MEMORANDUM

SUBJECT: Cascades I at Onion Creek Planned Unit Development Project Assessment –
CD-2015-0017

BRIEFING SUMMARY SHEET

Presentation of a Project Assessment Report for the Cascades I at Onion Creek Planned Unit Development, also known as Cascades Municipal Utility District No. 1, located at 11601, 11809, 11811 and 11819 South IH-35 Service Road Northbound, within the Onion Creek Watershed.

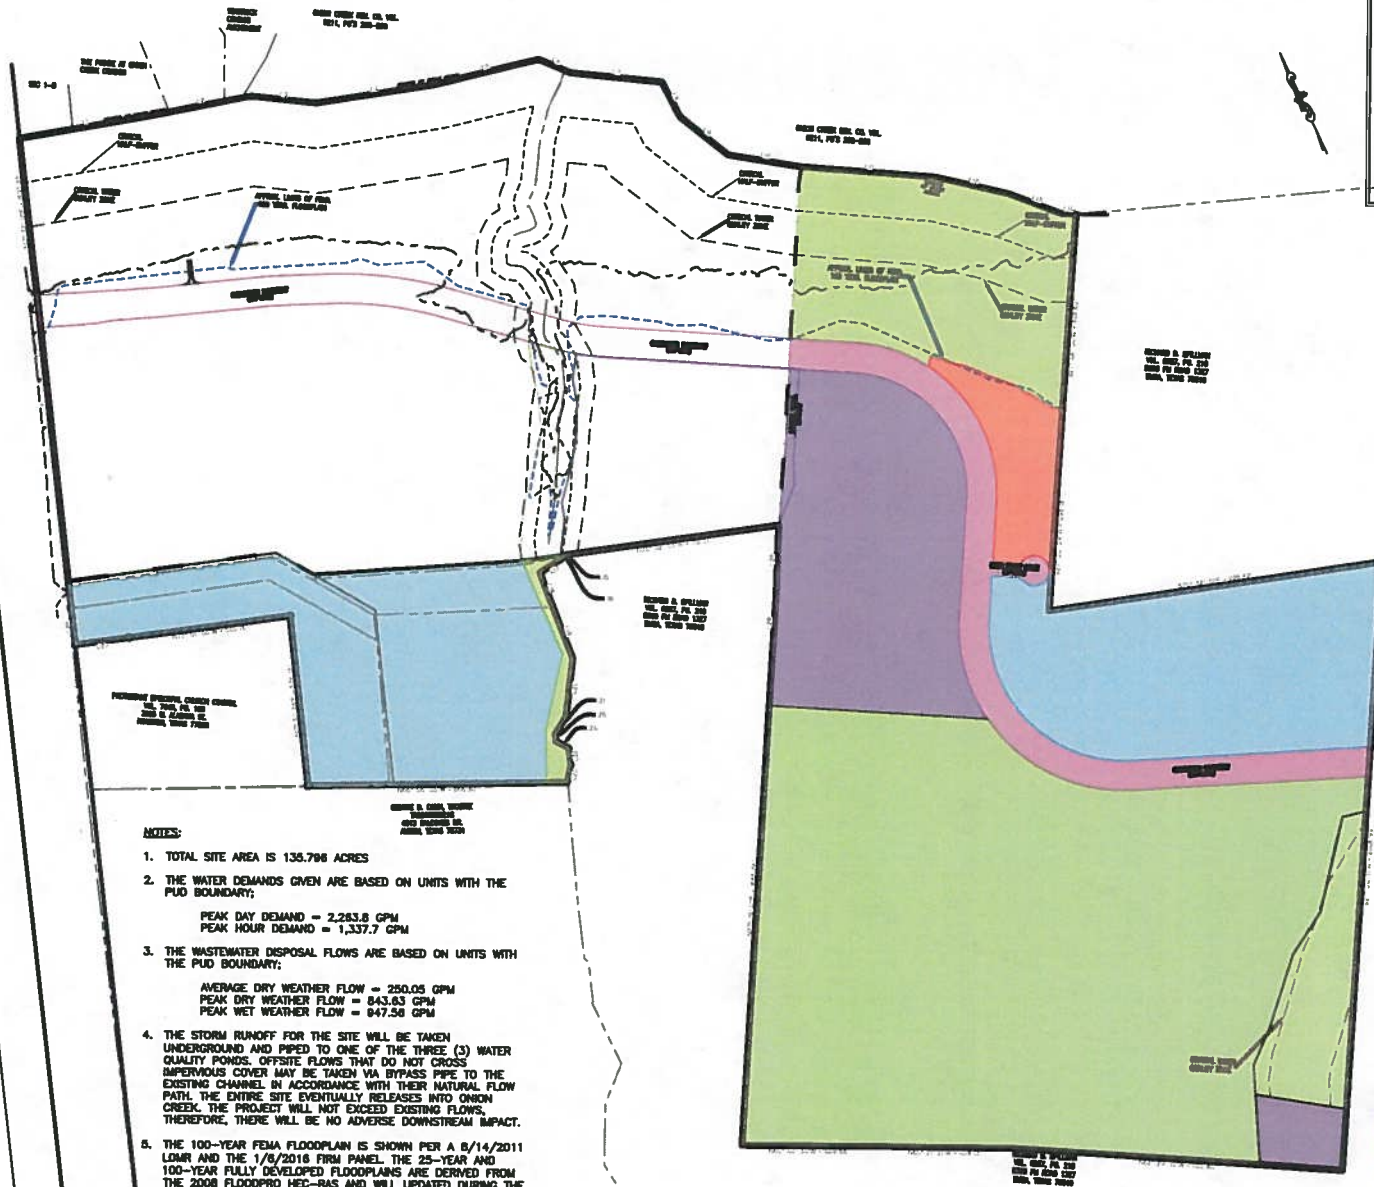
- SP 3. Please show on the land use plan the proposed 6 foot bike lanes along Cascade Parkway.

ZN 1. Add a vicinity map to the PUD Land Use Plan (re-label from Overall Site Plan) and submit an 8 ½ x 11 copy to the case manager.

ZN 2. Please identify adjacent land uses on the PUD Land Use Plan.

ZN 3. Label the floodplain areas on the PUD Land Use Plan.

ZN 4. Label Cascades Parkway on the PUD Land Use Plan.

ZN 5. Please identify the zoning base districts for each land use area on the PUD Land Use Plan. You may wish to designate each land use area by tract number, for easier identification.

ZN 6. Sheet 10 of the Development Assessment shows that 75 foot building areas are proposed. Please identify the land use area(s) where 75 foot buildings are proposed on the PUD Land Use Plan.

ZN 7. Please identify the proposed location of the Civic Reserve Community Center on the PUD Land Use Plan, as described in Exhibit E of the MUD Consent Agreement.
